RECORD OF DECISION AMENDMENT

ANACONDA REGIONAL WATER, WASTE, AND SOILS OPERABLE UNIT

*Anaconda Smelter National Priorities List Site
Anaconda – Deer Lodge County, Montana*

September 2011

Figure 3-1. Revised Ground Water Area of Concern
Anaconda Regional Water, Waste, & Soils OU
Anaconda Smelter NPL Site, Montana

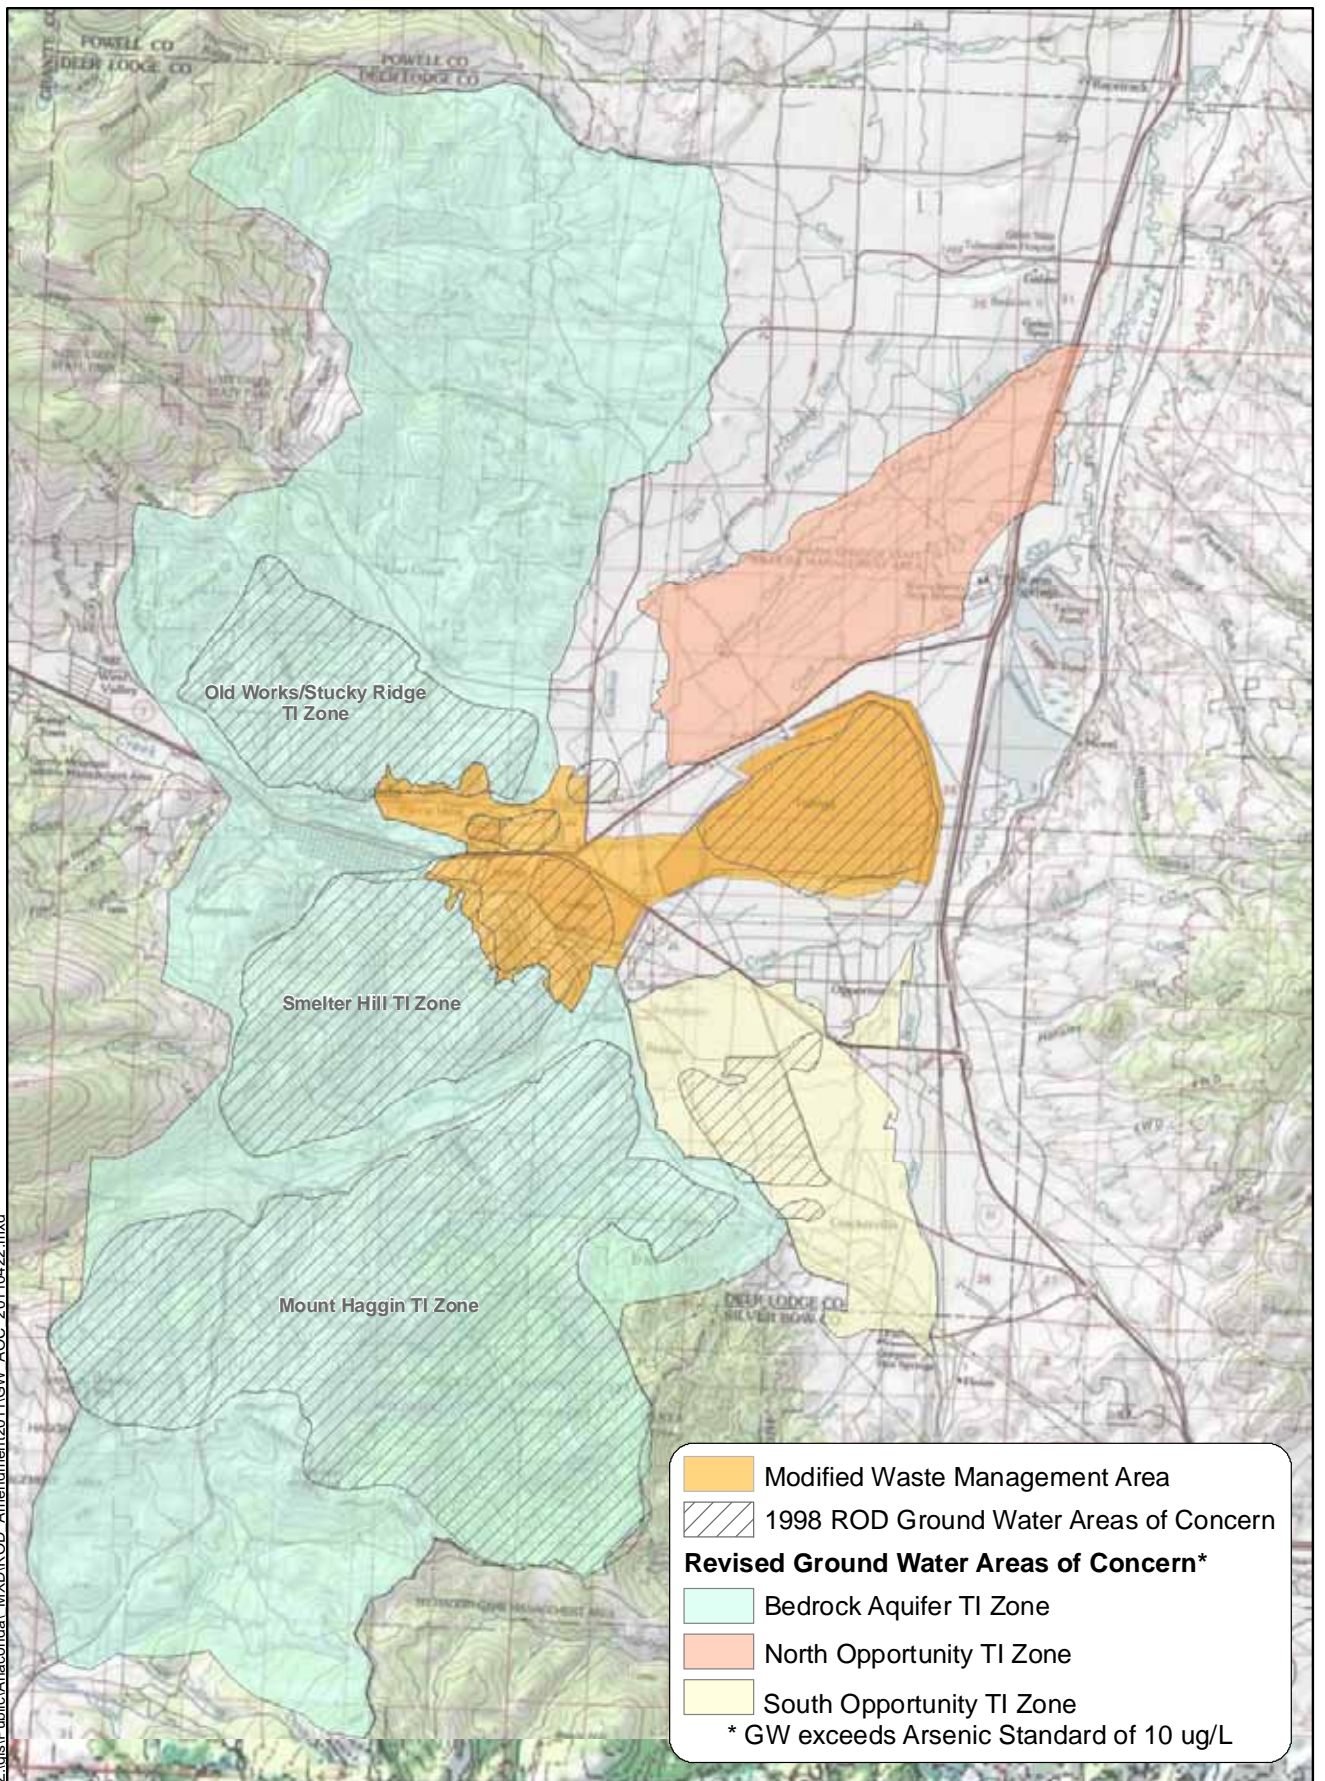
The 1998 ROD identified ground water areas of concern based on the existing arsenic RAG and site characterization at the time. Lowering the arsenic standard concentration to 10 µg/L has resulted in a significant increase in the size of the contaminant plume. In addition to the change in the standard, additional site characterization data collected during RD has resulted in better definition of areas of contamination. These investigations include spring and seep sampling in the uplands and wetland areas, installation of monitoring wells in the bedrock aquifer TI zone and around the waste management areas, and installation of piezometers in alluvial aquifer areas of concern. Figure 3-1 compares the new ground water area of concern

Figure 4-1. Opportunity Ponds Subarea Significant Changes
 Anaconda Regional Water, Waste, & Soils OU
 Anaconda Smelter NPL Site, Montana

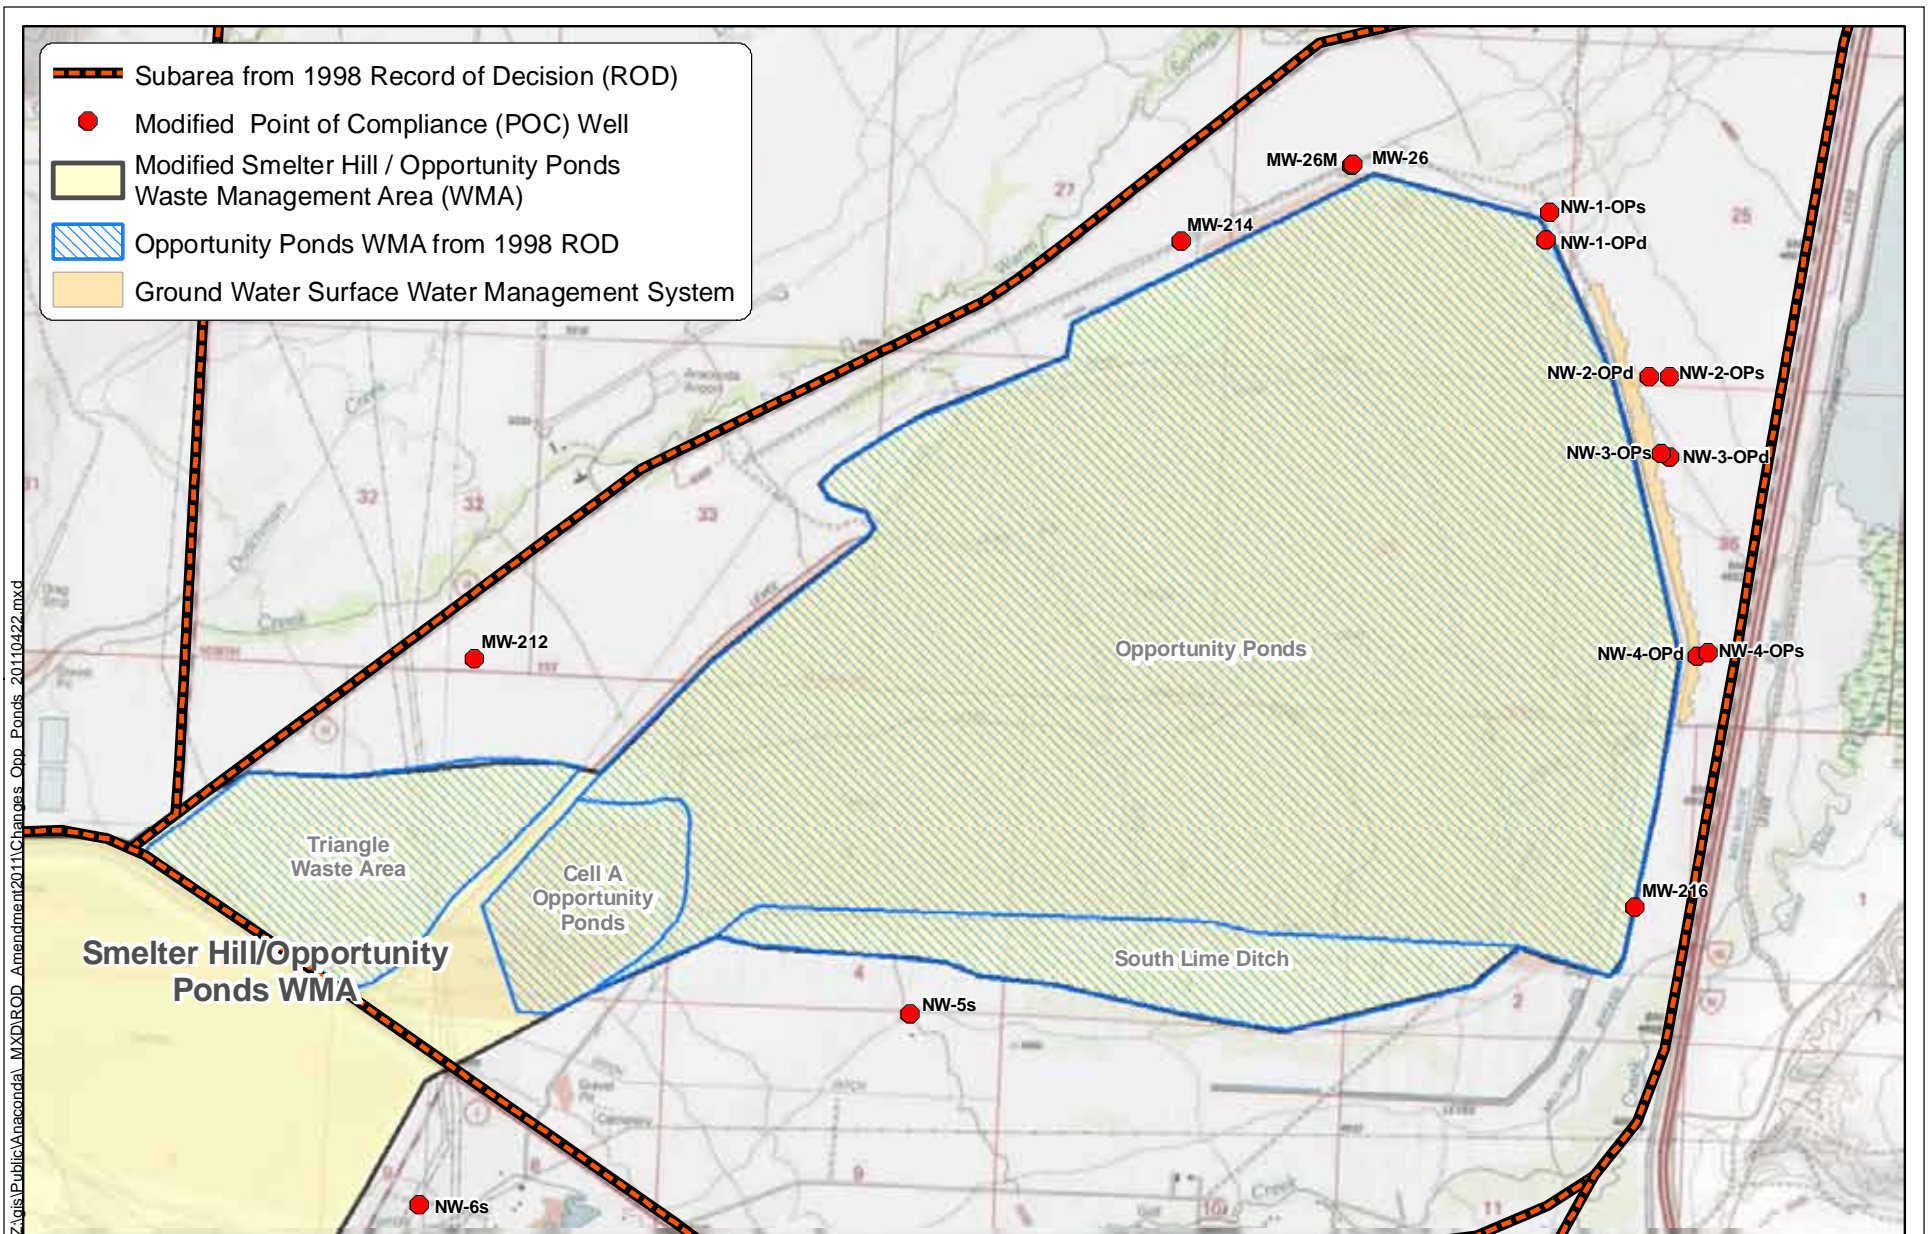
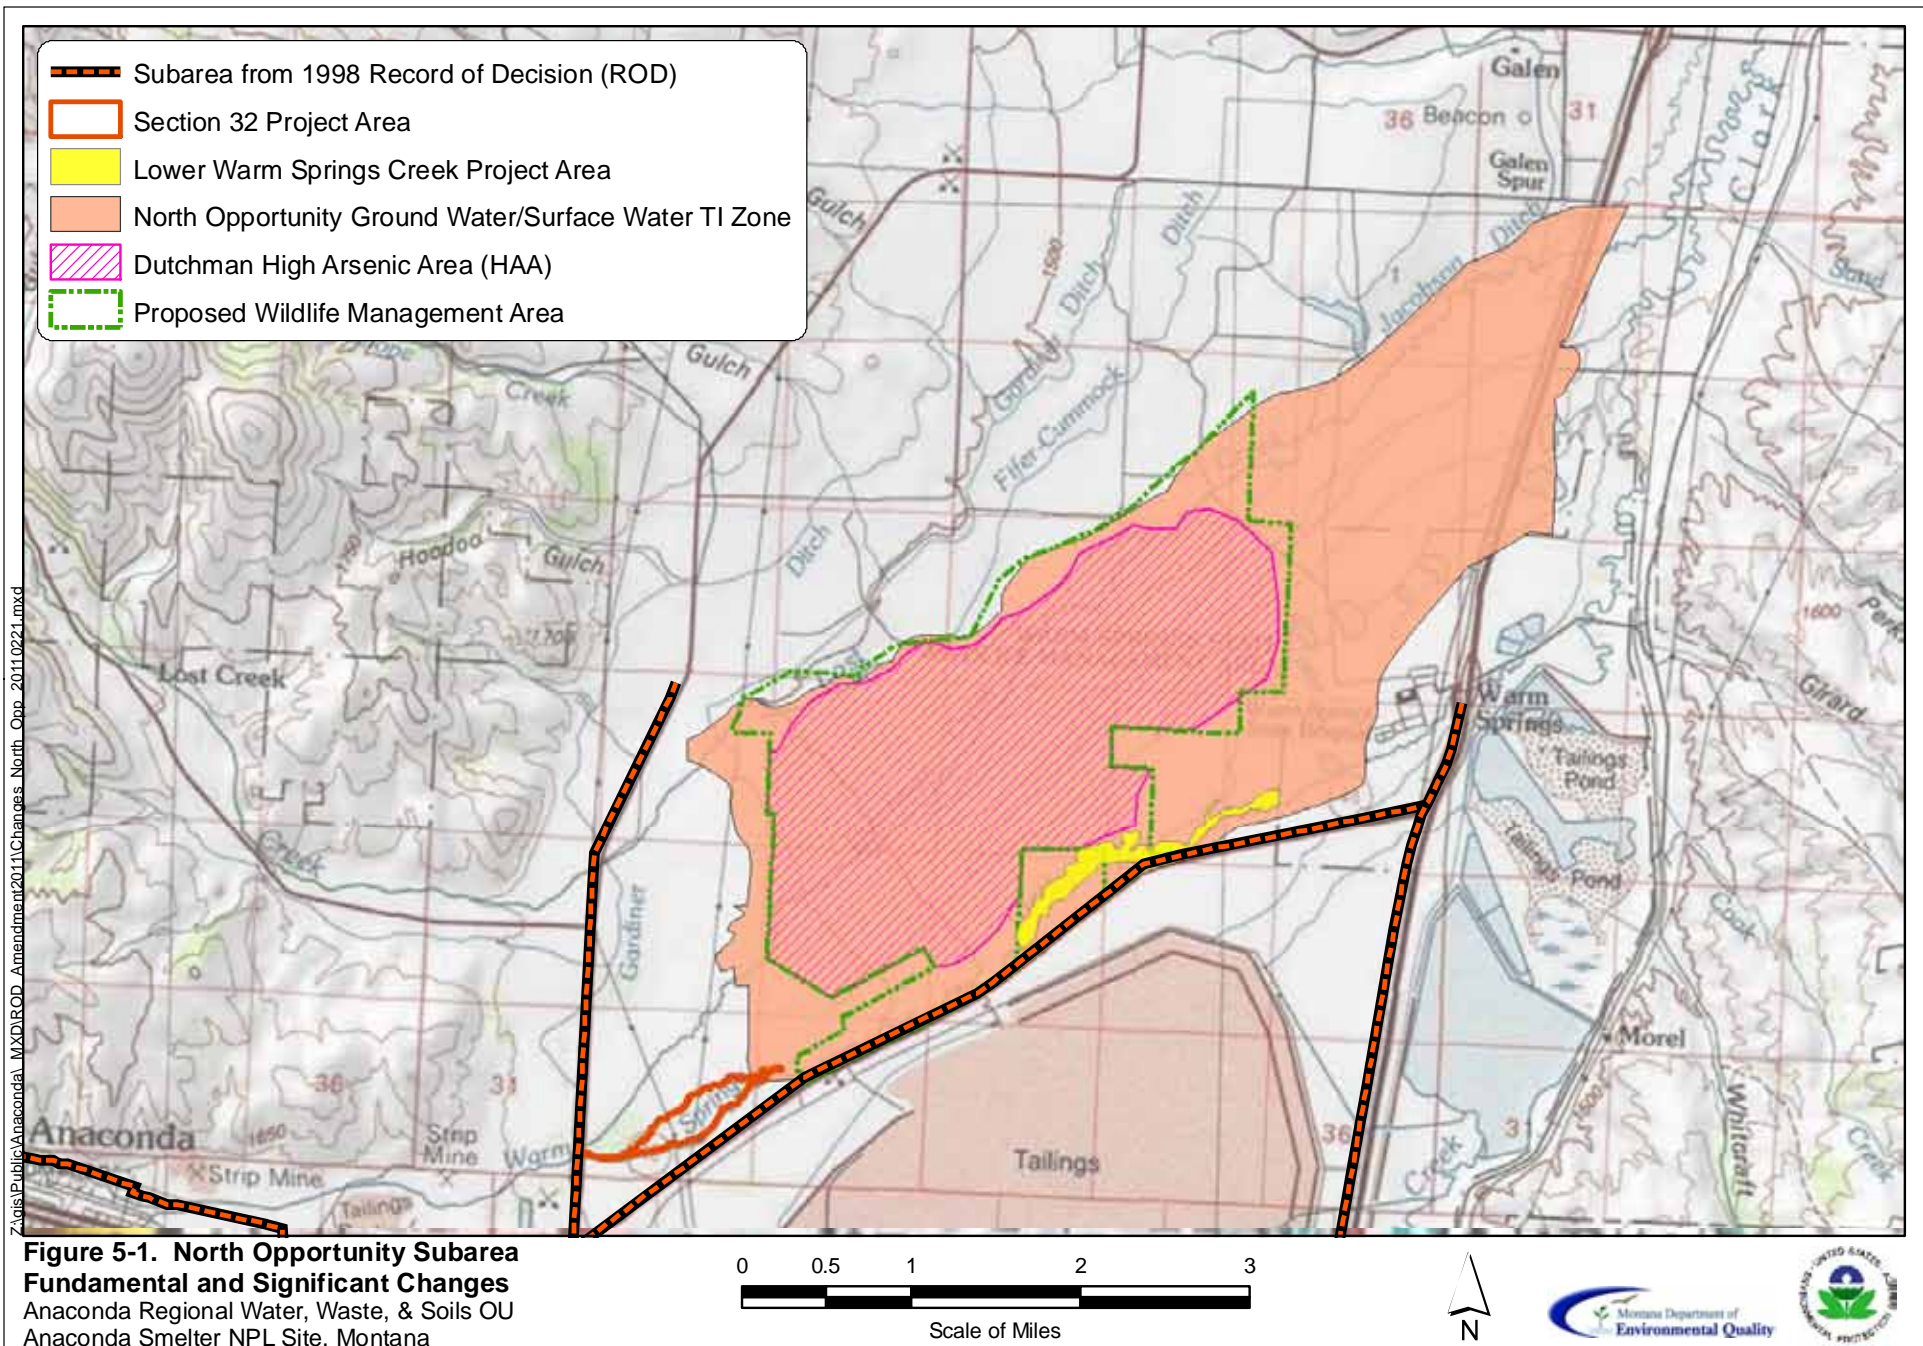
This ROD Amendment incorporates the Triangle Waste Area into the Opportunity Ponds WMA. Inclusion of the Triangle Waste Area into the Opportunity Ponds WMA leads to a merger of the Smelter Hill and Opportunity Ponds WMAs into one WMA, the Smelter Hill/Opportunity Ponds WMA. Figure 4-1 shows the revised Opportunity Ponds WMA boundary compared to the 1998 boundary, and new ground water POC.

Remedial requirements for ground water containment at the Smelter Hill/Opportunity Ponds WMA identified in the 1998 ROD are unchanged. The Smelter Hill/Opportunity Ponds ground water POCs are shown on Figure 4-1.

1. The Opportunity Ponds WMA has been expanded, as shown in Figure 4-1.
2. The Smelter Hill WMA has been expanded, as shown in Figure 8-1.
3. The Opportunity Ponds and Smelter Hill WMAs have been merged into a single WMA, as shown in Figure 3-3.
4. The Old Works WMA has been expanded, as shown in Figure 7-1.
5. The Uplands Soils Areas of Concern has been expanded, as shown in Figure 3-4.
6. A Dutchman HAA has been designated, as shown in Figure 5-1
7. A Smelter Hill HAA has been designated, as shown in Figure 8-1.
8. Additional abandoned railroad wastes have been identified for disposal into a WMA, as described in Section 8.3.

9. New POC locations have been established for the Smelter Hill/Opportunity Ponds WMA, as shown in Figure 4-1.
10. A GWSWMS has been constructed along a portion of the toe of the Opportunity Ponds tailings impoundment to address potential arsenic ground water plume movement.
11. New POC locations have been established for the Old Works WMA, as shown in Figure 7-1.
12. The arsenic human health standard for ground water has been waived for the North Opportunity Alluvial Aquifer TI Zone, as shown in Figure 5-1.

**Figure 6-1. South Opportunity Subarea
Fundamental Changes**
Anaconda Regional Water, Waste, & Soils OU
Anaconda Smelter NPL Site, Montana

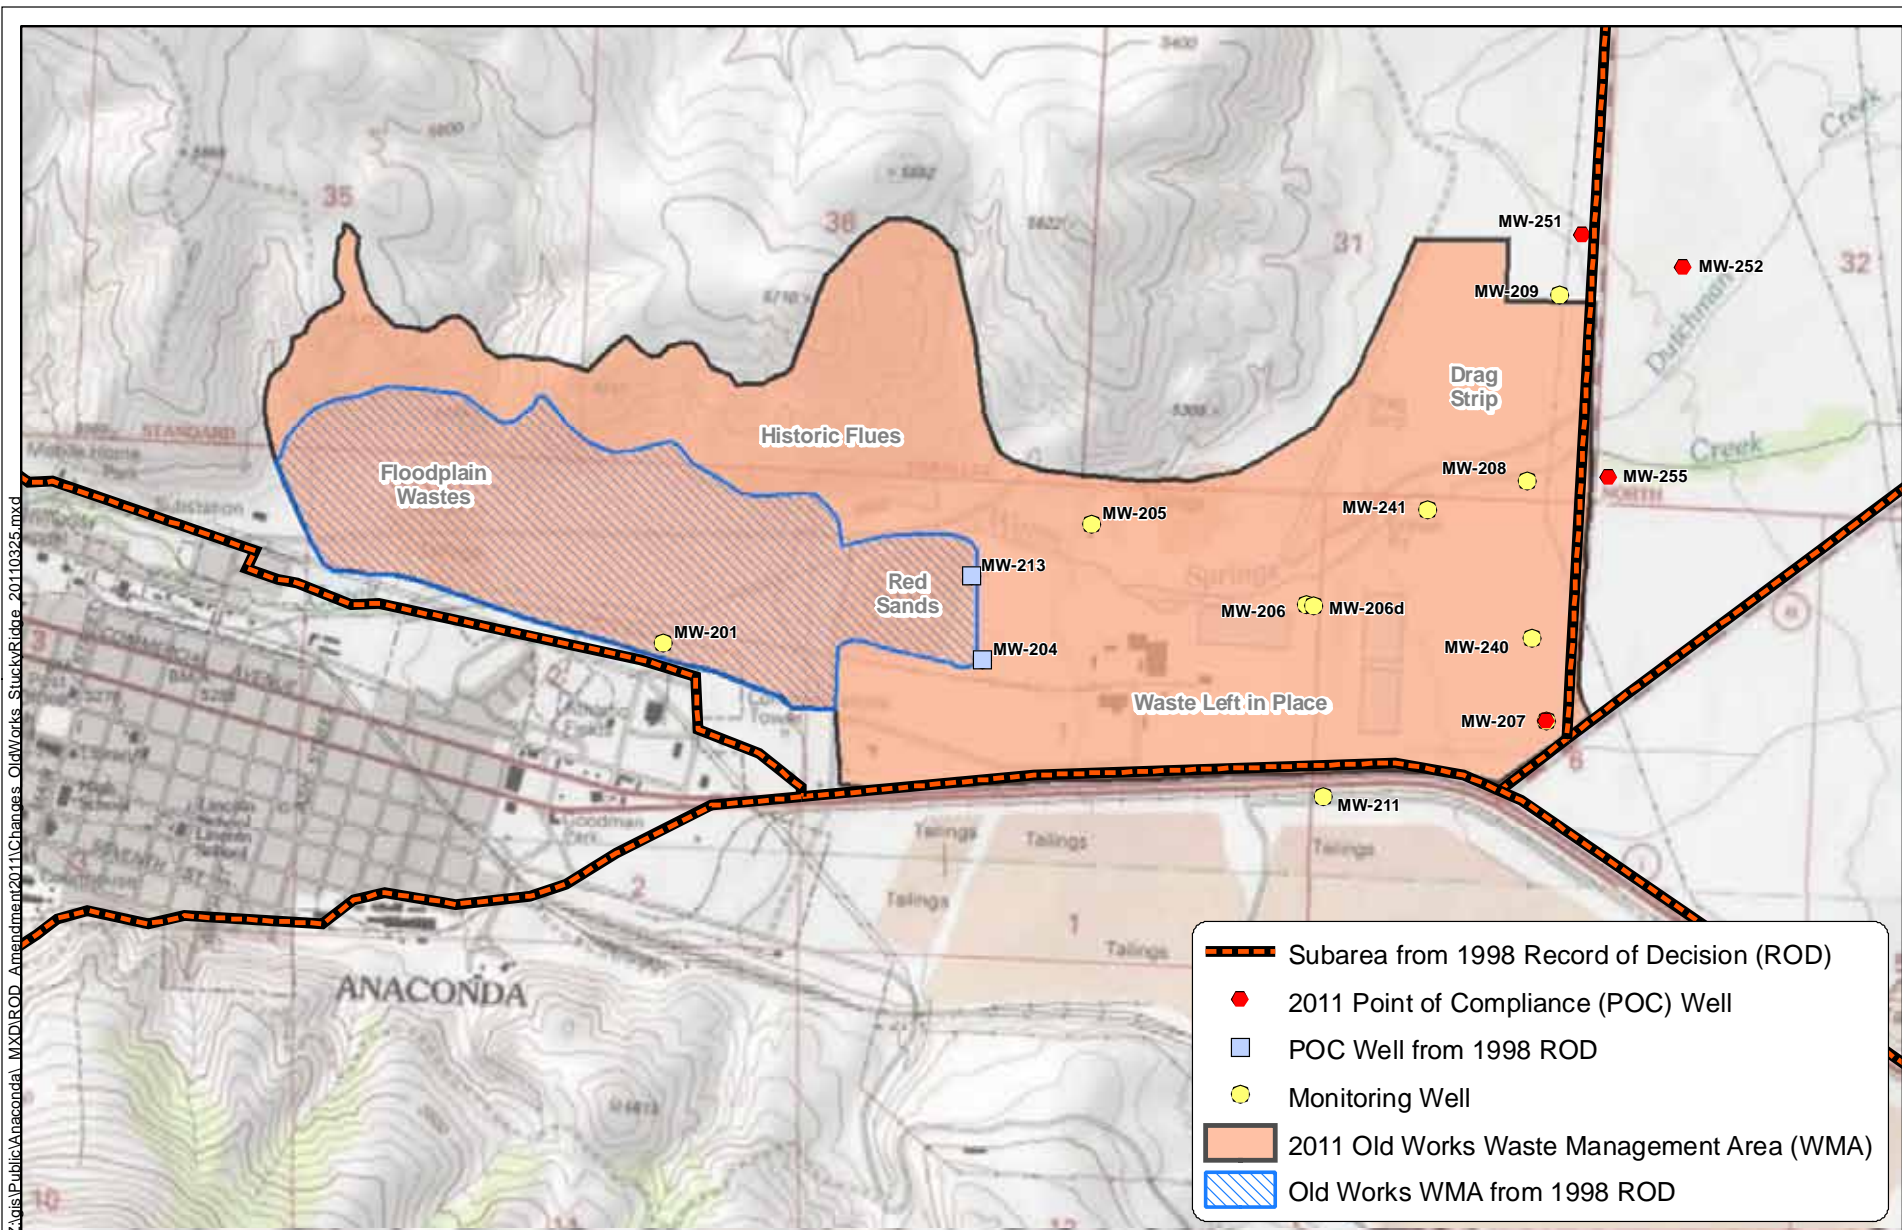
During RD, two other locations (shown on Figure 6-1) where surface water intercepts railroad embankment materials and subsequently results in COCs leaching into surface water were identified and included. These areas, as well as the railroad crossings at Mill and Willow Creeks, will be addressed as part of remedy and are included in the RDU 5 Active Railroad East/Blue Lagoon RA Work Plan/Final Design Report (Atlantic Richfield 2007a). Improvements to minimize surface water contamination at the areas are also required and are identified in this work plan.

The South Opportunity Ground Water/ Surface Water Area of Concern consists of valley bottom land located within an area generally bounded by Mill Creek to the north, the Streamside Tailings OU to the east, the Silver Bow County line to the south, and uplands associated with the Mount Haggin Wildlife Management Area (also the bedrock TI Zone) to the west. Figure 6-1 shows the South Opportunity Ground Water/ Surface Water Area of Concern.

Surface water investigations conducted in 1993 and 2007 attempted to sample all tributaries to lower Willow Creek. All samples exceeded 10 µg/L arsenic confirming the widespread nature of surface water contamination. Figure 6-1 delineates the South Opportunity ground water/surface water TI zone. The area generally includes the valley bottom land located within an area bounded by Mill Creek or Highway 1 to the north, the Streamside Tailings OU to the east, the Silver Bow County line to the south, and uplands associated with the Mount Haggin WMA (also the bedrock TI zone) to the west. Downgradient movement of the plume is hydraulically controlled by discharge into surface water either along Willow Creek or drain tiles. Because of the connection between the extent of wetlands and ground water contamination, wetlands on the north side of Highway 1 are included in the TI zone. Wetlands further north are not included in the TI zone because no data have been collected to indicate that shallow ground water contamination exists in that area. Data from drain tiles and domestic wells indicate very low arsenic concentrations in ground water north of the TI zone.

13. The arsenic human health standard for ground water has been waived for the South Opportunity Alluvial Aquifer TI Zone, as shown in Figure 6-1.
14. The Bedrock Aquifer TI Zone has been expanded, as shown in Figure 9-1.
15. The remedy for the Blue Lagoon has been changed from drainage control improvements to removal, as discussed in Section 6.2.
16. The remedy for the Yellow Ditch requires significantly more areas of removal than that originally anticipated under the ROD, as discussed in Section 6.3.
17. A Domestic Well Monitoring and Replacement Program is being implemented to ensure that domestic well users do not drink ground water above human health standards, as shown on Figure 9-2 and discussed in Section 9.3.
18. Revised ground water standards to meet current state and federal requirements are adopted, as identified in Table 3-1.
